# **Tyre Pressure Monitoring Systems**

**OICA position on  
GRRF/2009/10  
(proposal for a new UNECE  
regulation on TPMS)**

# Comparison of warning thresholds

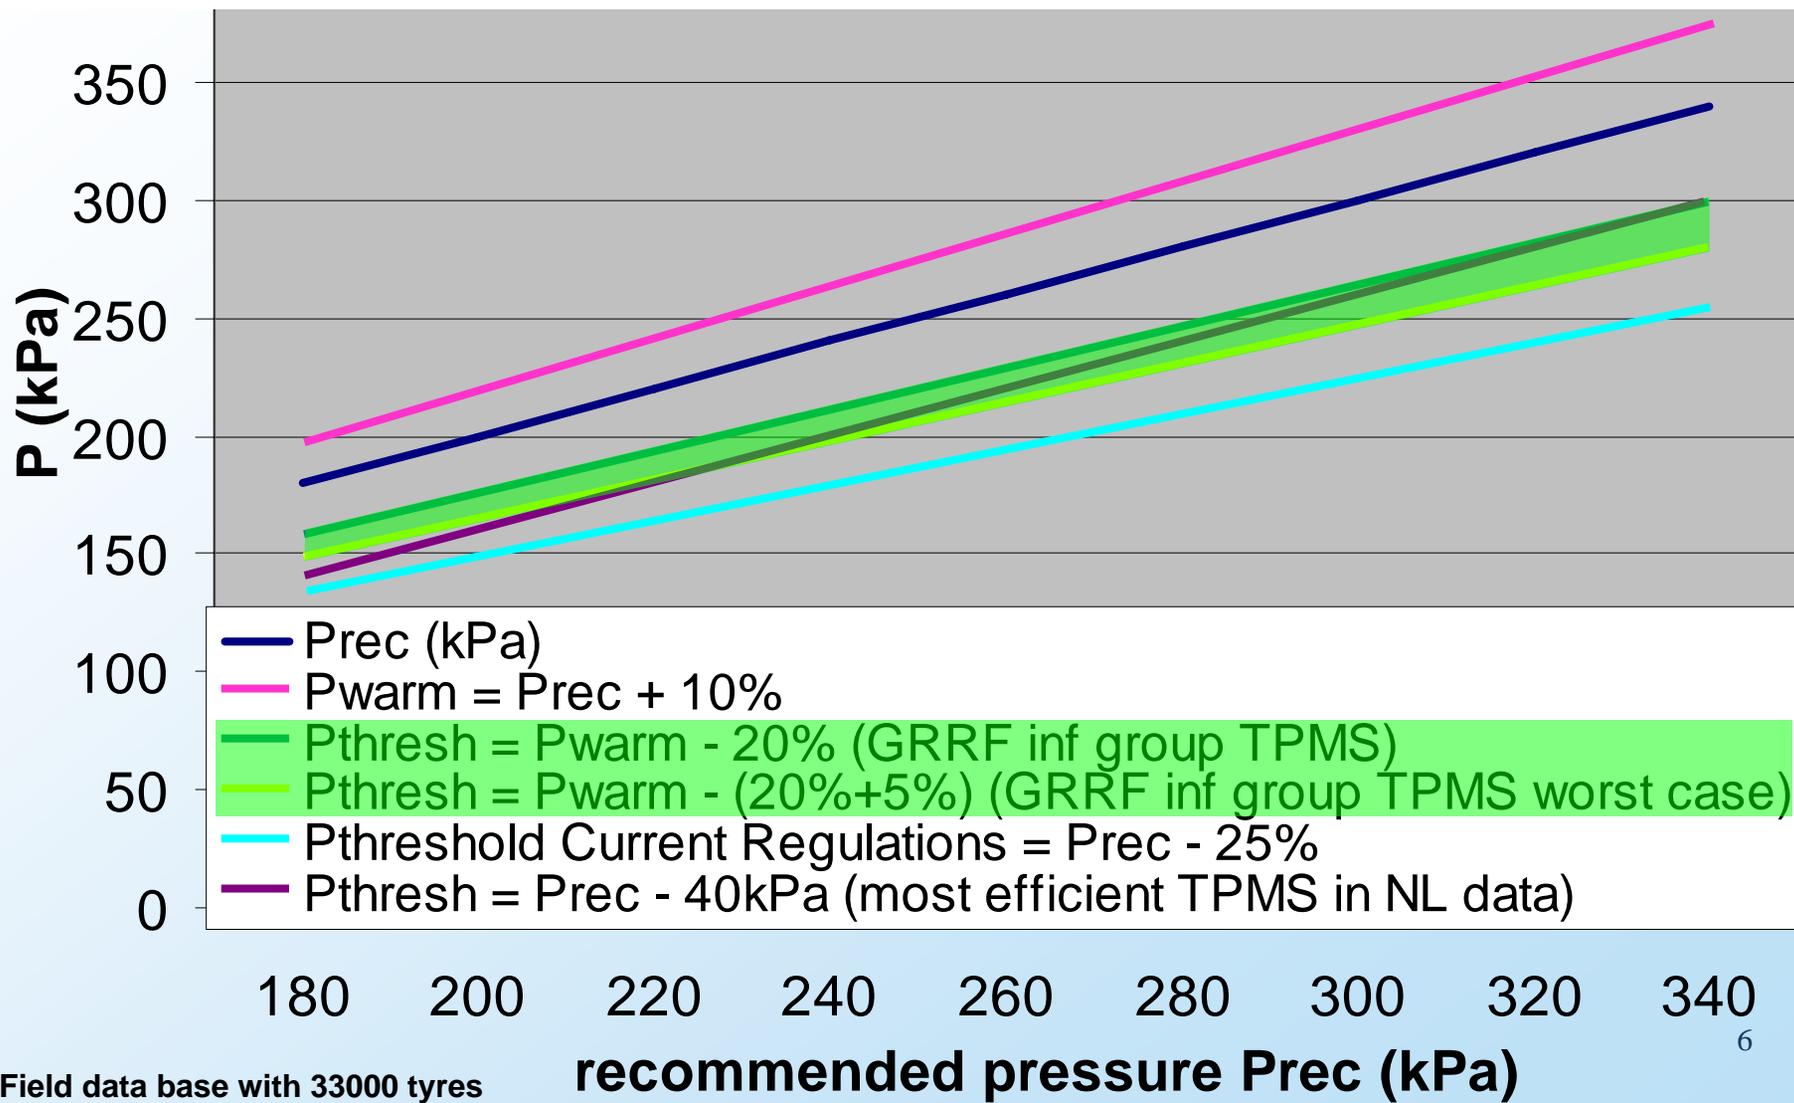
⇒ The requirements proposed by the GRRF informal group are more severe than current regulations and than the most efficient TPMS in the NL data base\*.

# Why more severe requirements would not increase the benefit? (1)

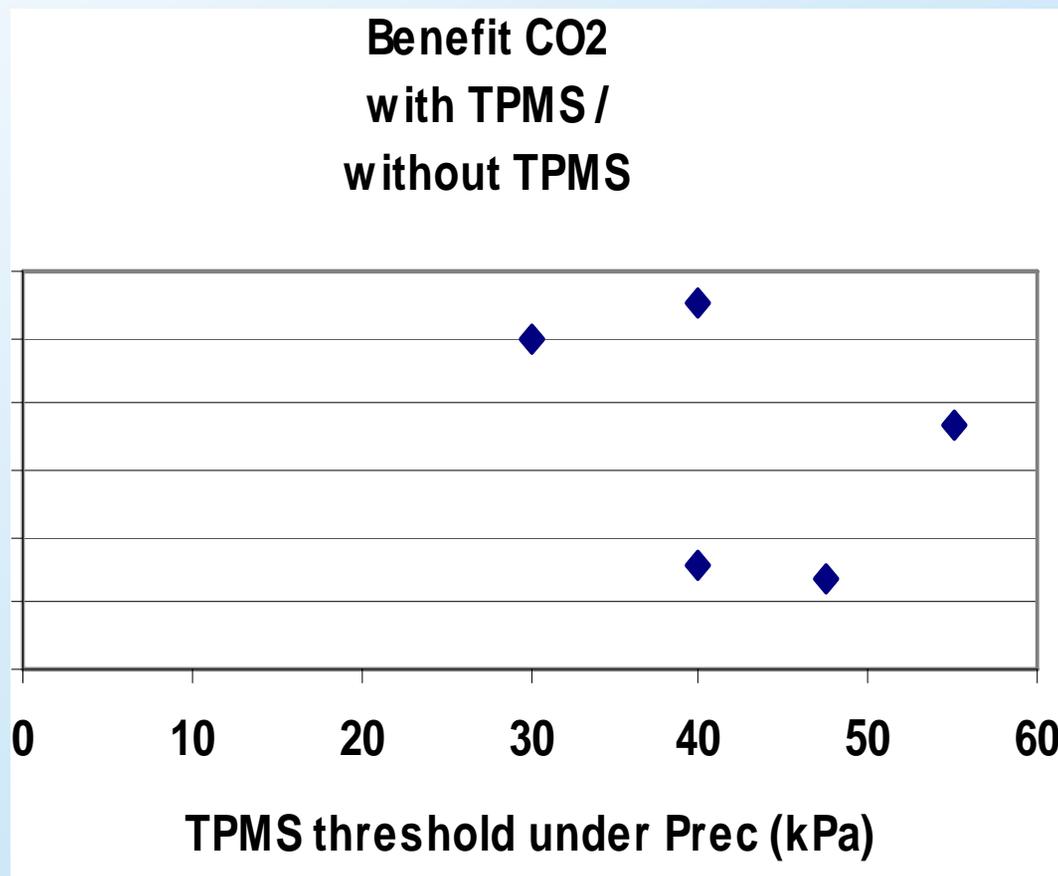
The NL field data\* has shown that the real world benefit of a given TPMS system is not linear to its warning threshold.

# Why more severe requirements would not improve the benefit? (2)

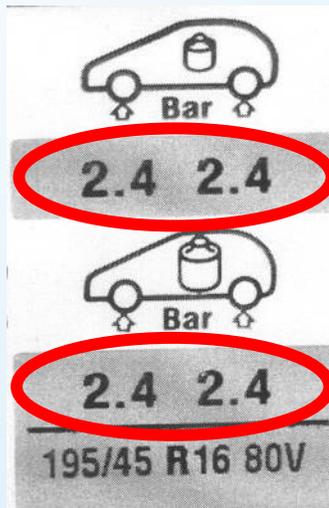
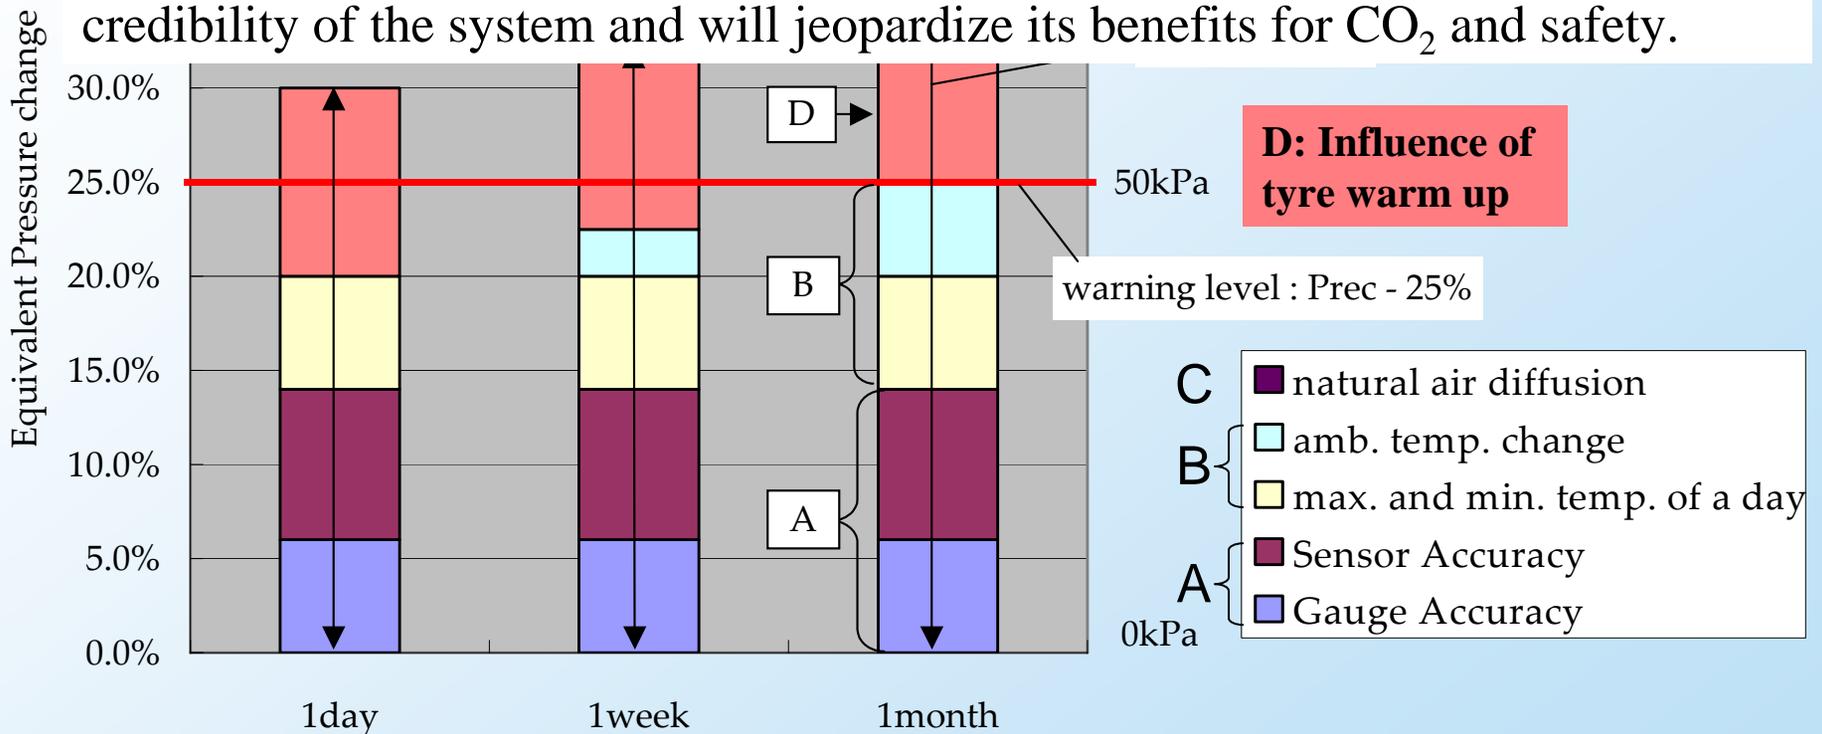
A tight threshold is understandable to the user in case of one unique value for  $P_{rec}$ .

However, such severity becomes nonsense if  $P_{rec}$  varies in a wide range.

**Range of 90 kPa**

**Range of 140 kPa**

A fine pressure adjustment according to the actual service conditions is nearly impossible. In consequence, a TPMS alert threshold which is closer to  $P_{rec}$  than 25% is not appropriate. 8

# Accuracy of infrastructure

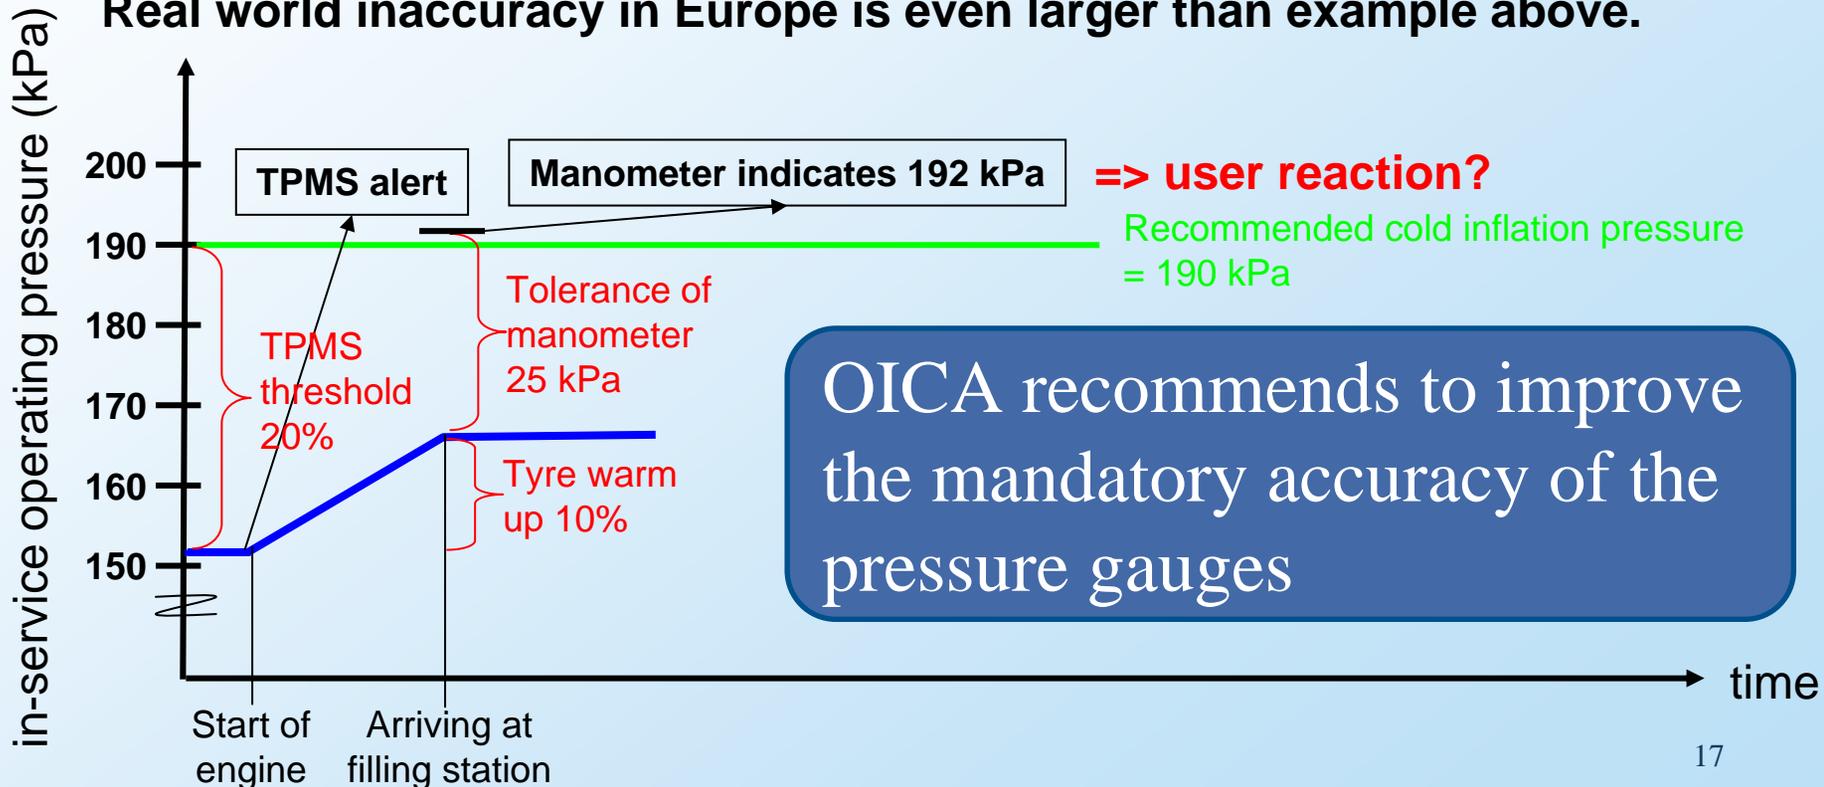
According to European Directive 86/217/EEC, for tyre inflation pressures up to 400 kPa, the maximum error of a manometer shall be not greater than  $\pm 8\text{kPa}$  ( $\Rightarrow$  amplitude of 16 kPa). According to national calibration laws (e.g. Germany), the error may increase up to factor 2 ( $\Rightarrow$  amplitude of 32 kPa) during the service live of a manometer.

**Real world inaccuracy in Europe is even larger than example above.**
